PERMIT SET

COURTYARDS - BUILDING E

SIGNER : DAS	DRAWN : DAS	
ARCHITECT : DAS	CHECKED : AAT	
ENGINEER :	APPROVED : CRJ	
REVISION DESCRIPTION		DATE
Rev 1 - Permit Comments		02/15/24

DRAWING TITLE
FIRST FLOOR PLAN - IL UNITS EDGE OF SLAB

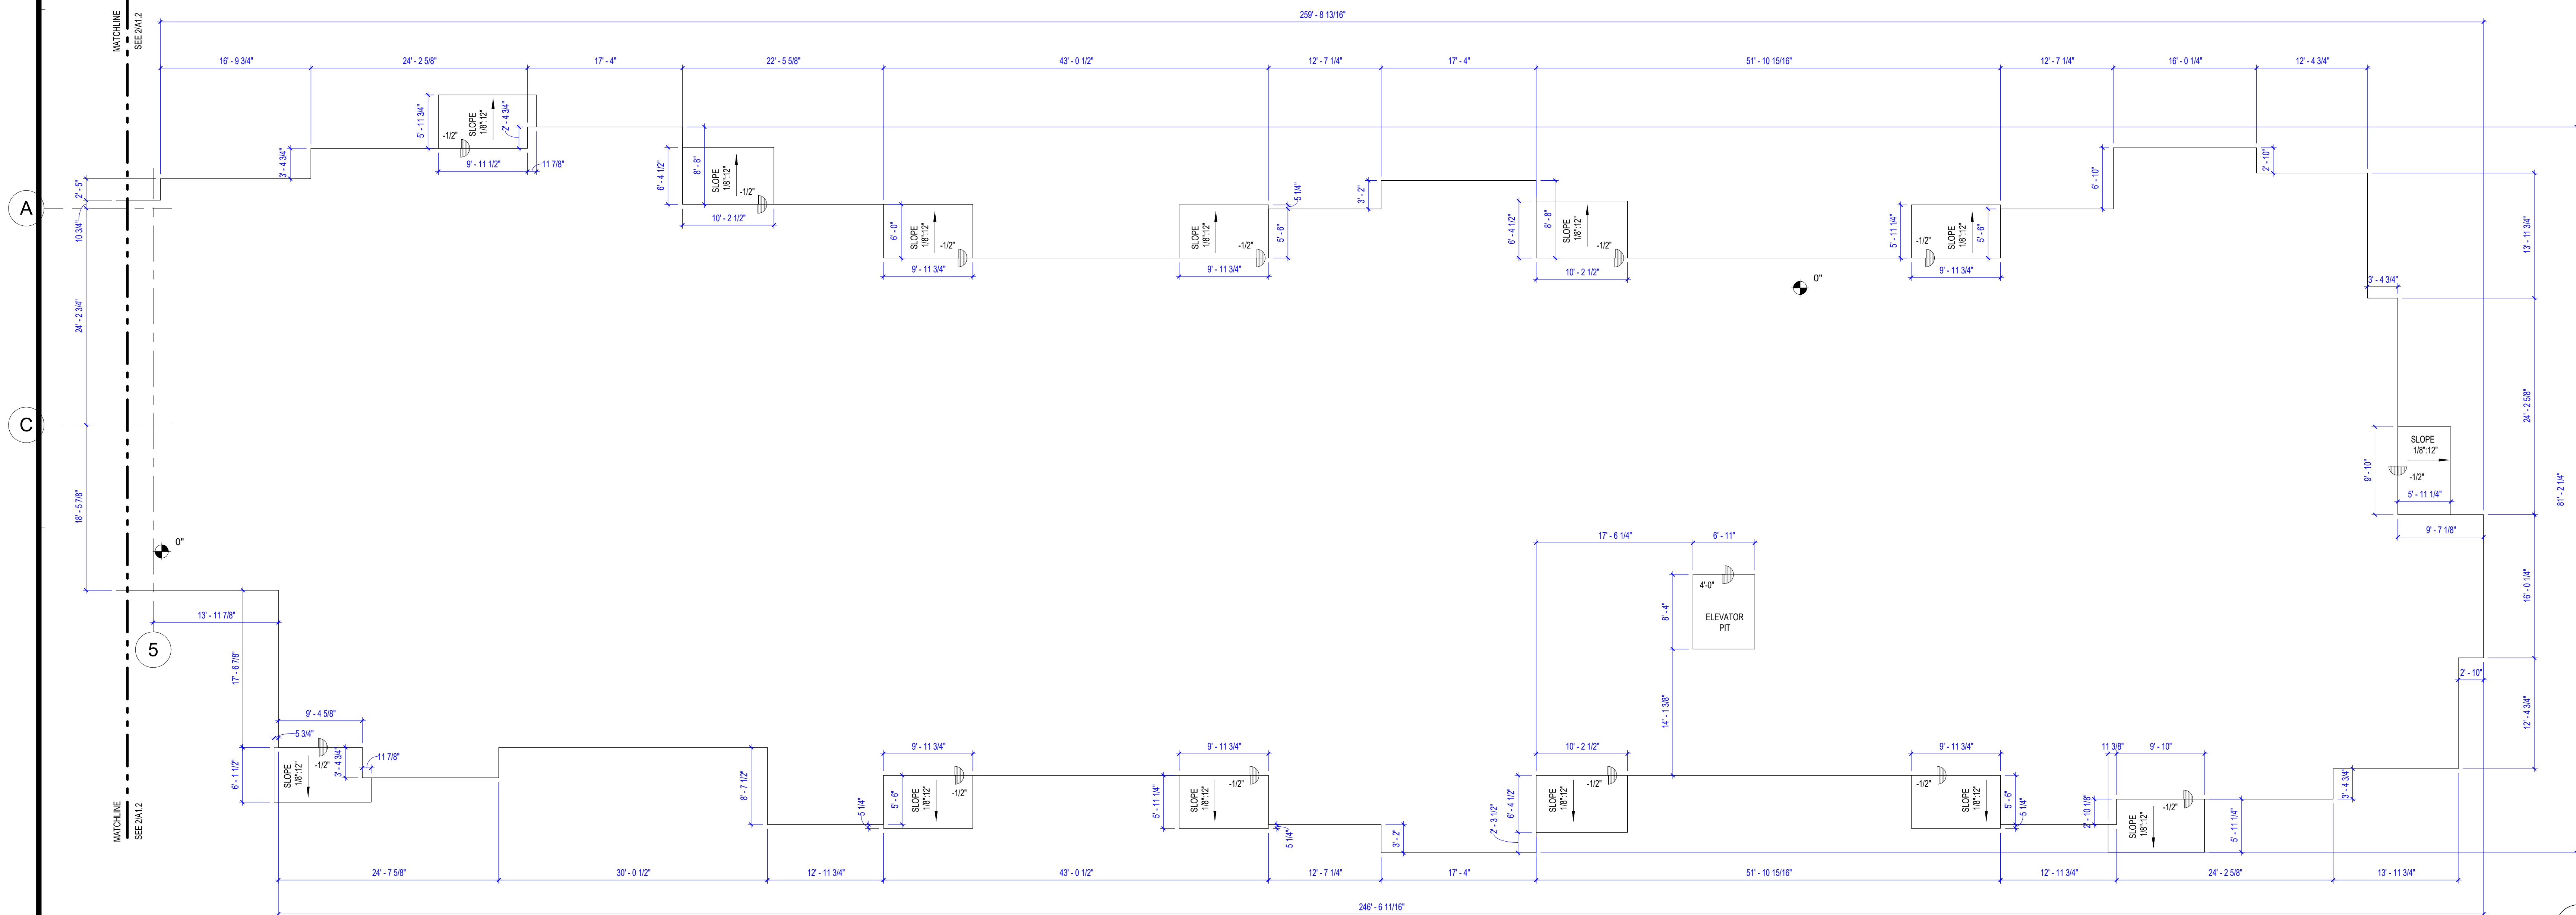
DIMENSIONS ADDED AND ADJUSTED

THIRD, FOURTH AND
ROOF FLOOR PLANS -
ATRIUM

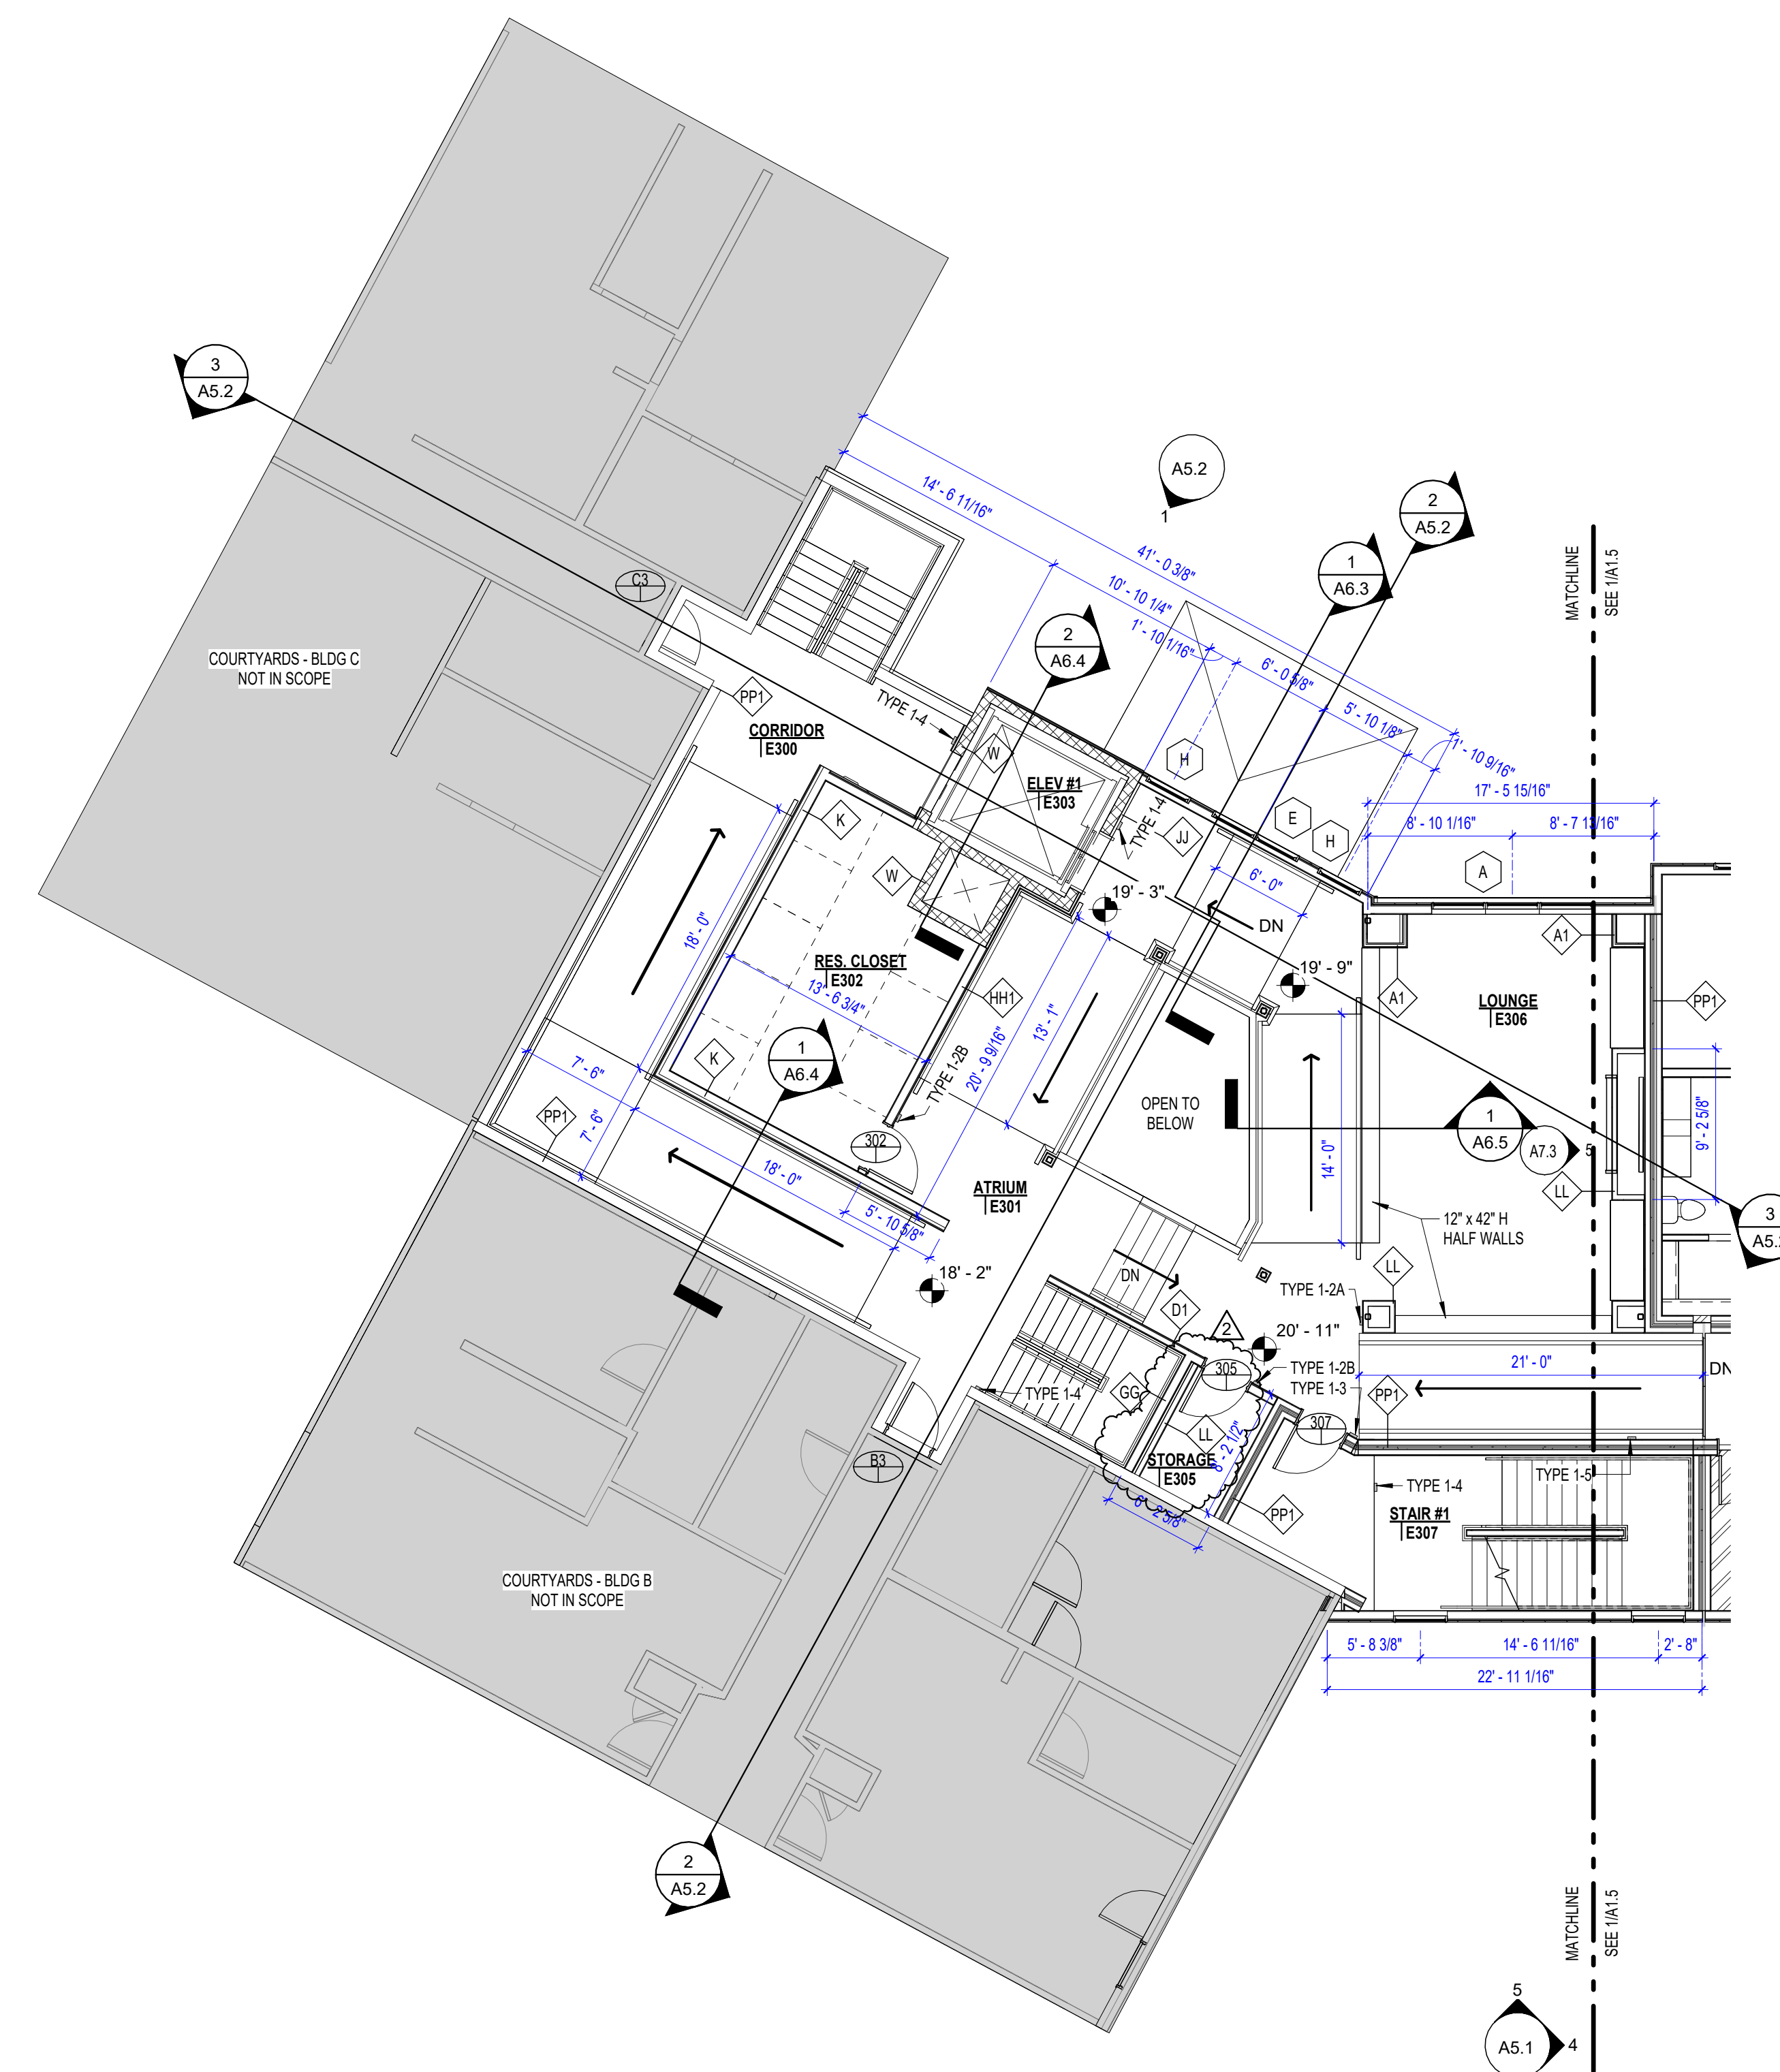
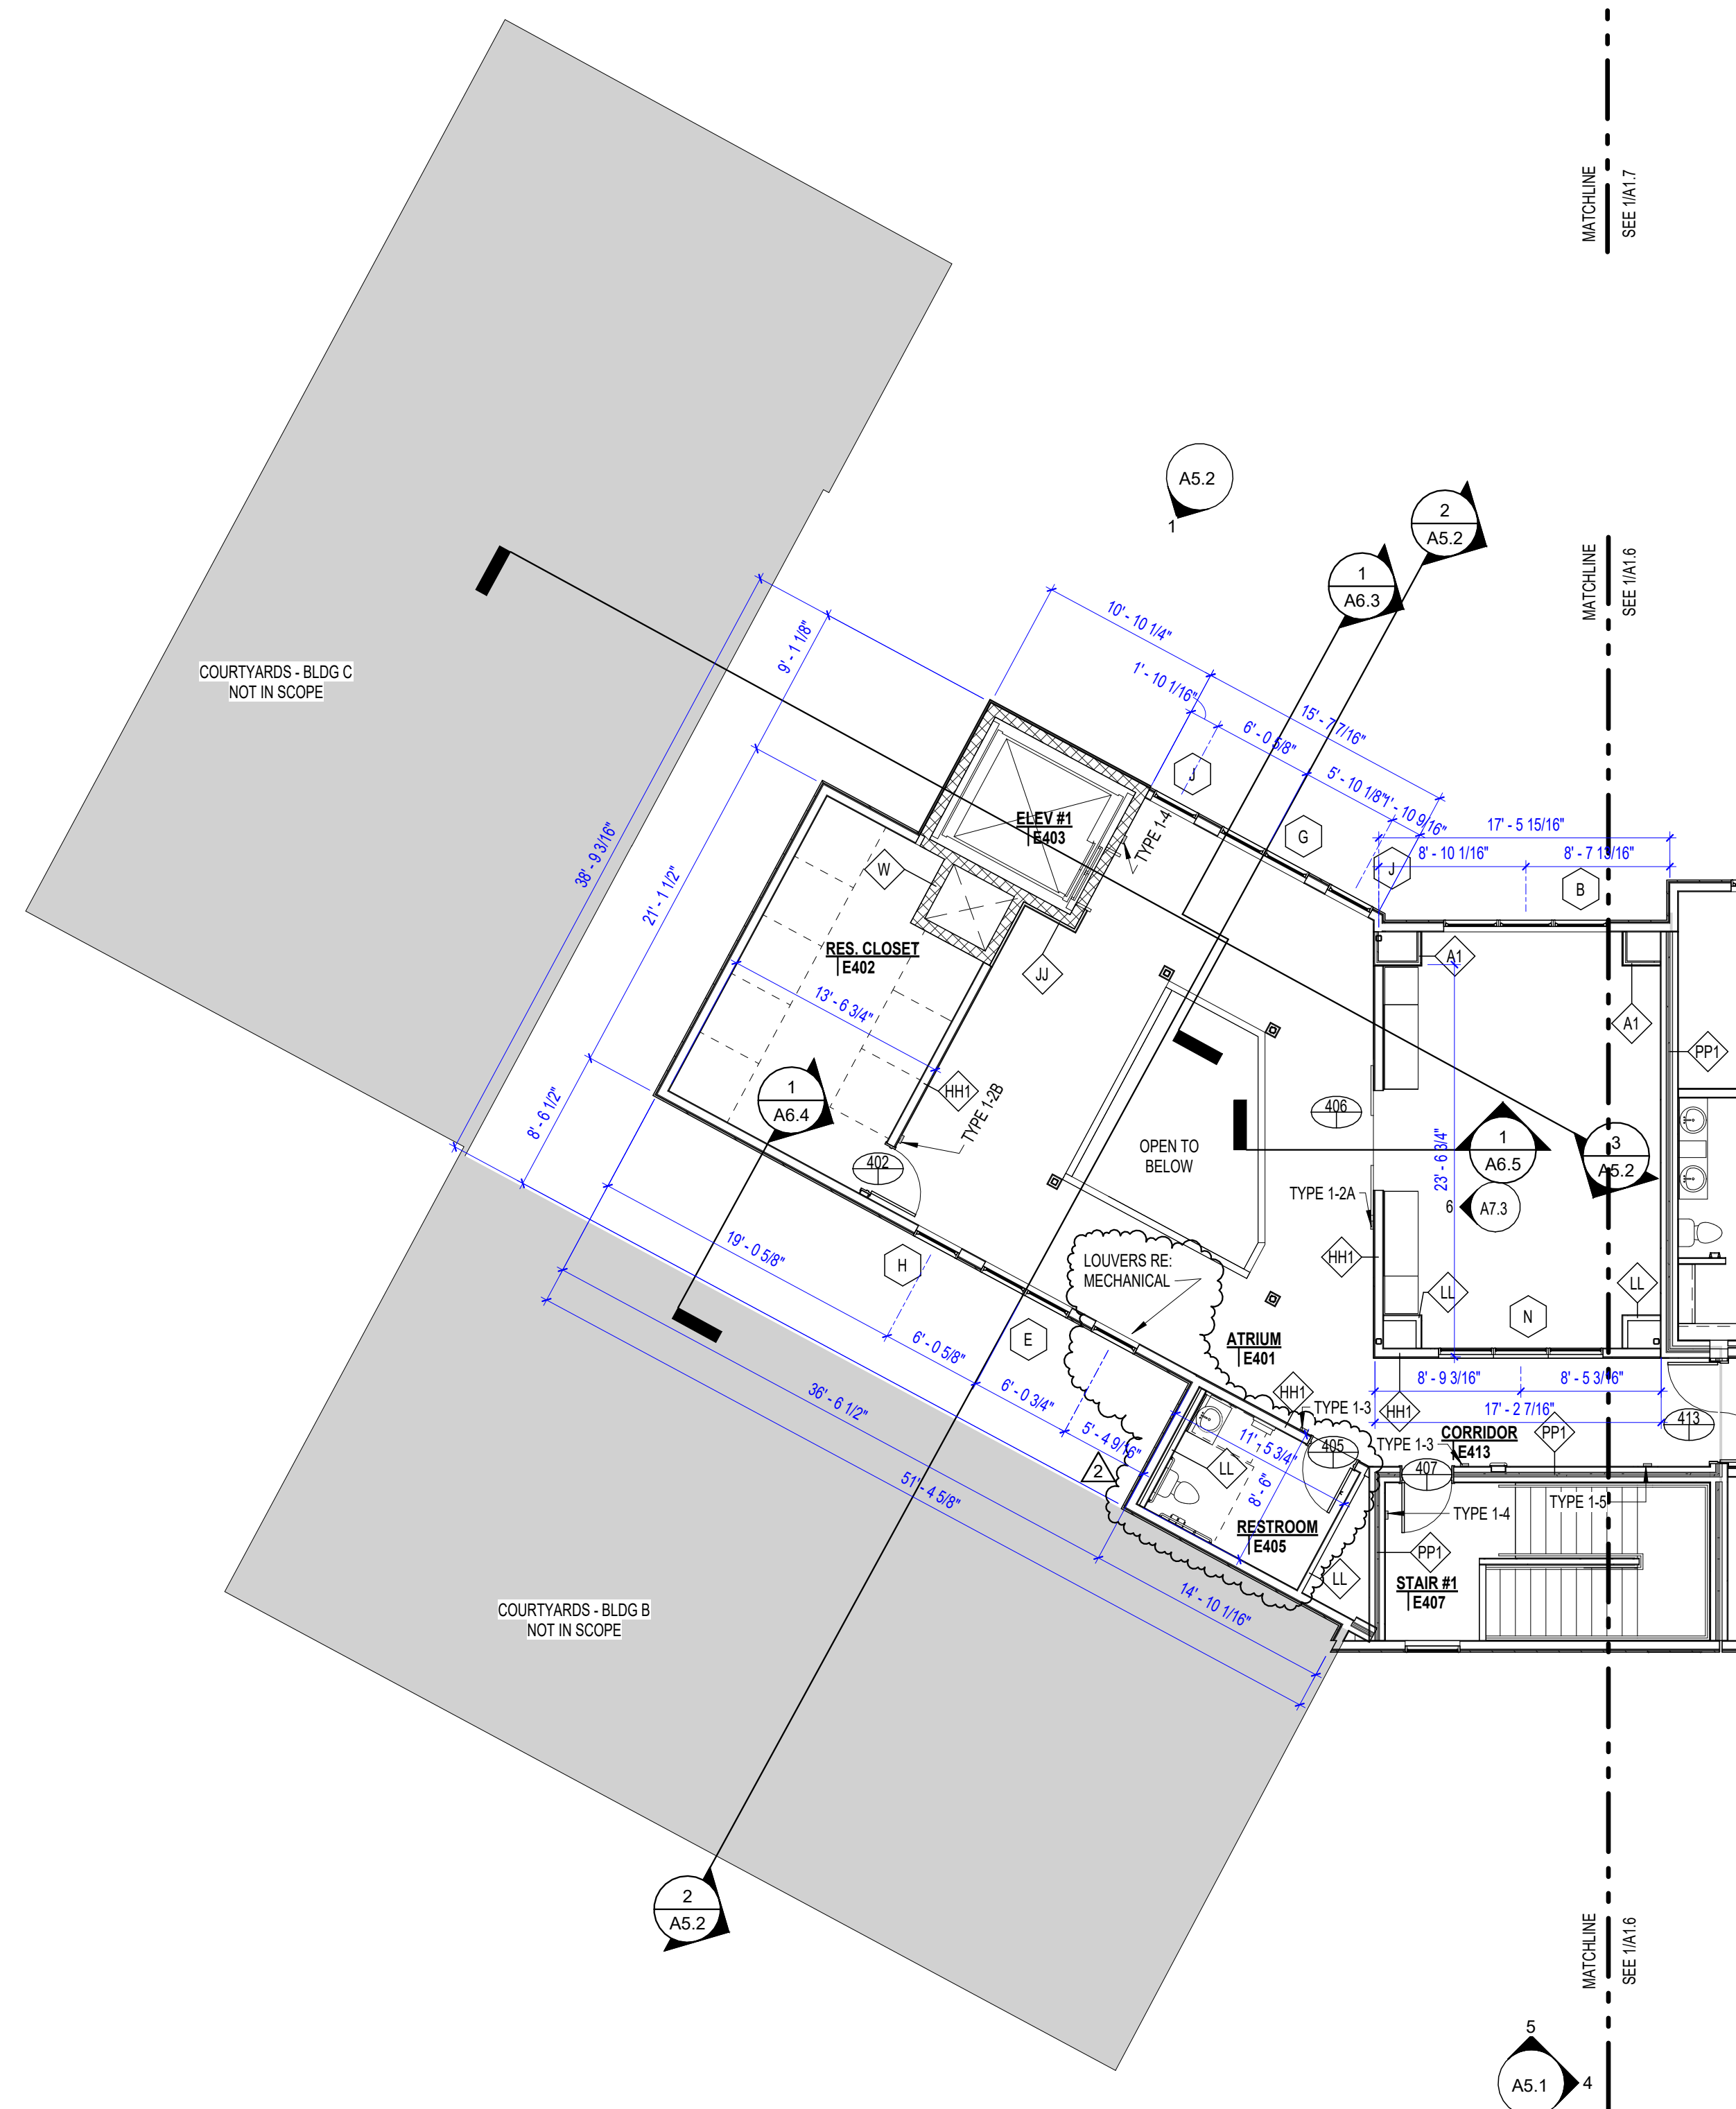
DIMENSIONS ADDED AND ADJUSTED
